**Response to NRC Request for Additional Information on  
WCAP-17057-P, Revision 0, "GSI-191 Fuel Assembly Test Report for PWROG"**

**February 2010**

This document provides responses to requests for additional information [1] related to WCAP-17057-P, Revision 0.

Figure 1-1: Microtherm – Individual Particle

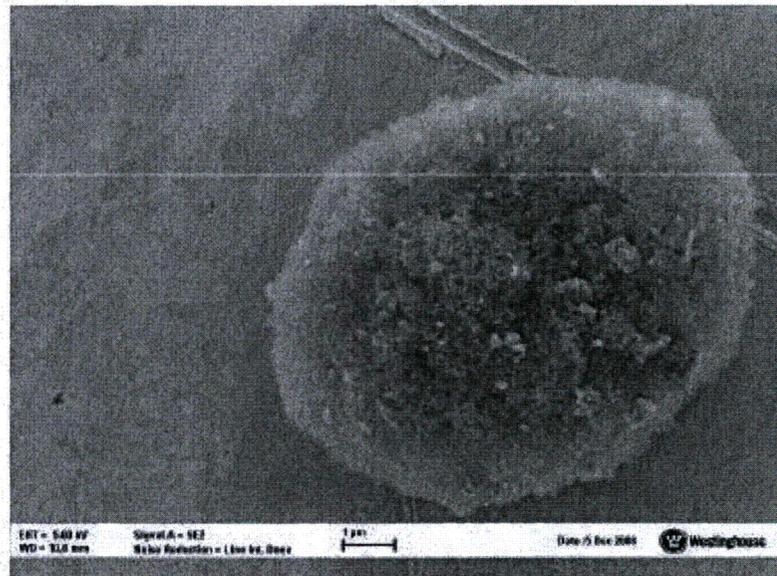
*Page 7-2, Table 7-2 lists a maximum microporous insulation debris load of 3.2 lbm while the maximum quantity tested was 1.47 lbm: Please discuss why a 2.2x factor above the tested amount is acceptable for microporous insulation.*

Microporous insulation does have a fibrous content which is removed when the microporous insulation passes through the sump screen. The preparation of the microporous material for fuel assembly tests simulated this process. The microporous insulation Microtherm was obtained from Microtherm, Inc. The material was supplied in a pulverized form. It was passed through a #7 sieve with a hole size of 0.11". The sieving is necessary to obtain test material that is representative of Microtherm that would pass through the sump screen. Then the material was characterized by scanning electron microscopy. An individual particle of microporous silica is shown in Figure 1-1. A lower magnification image showing multiple Microtherm particles is displayed in Figure 1-2. The processed Microtherm material appeared to be almost completely devoid of fibers suggesting that they had been removed by the screening process and is essentially a particulate.
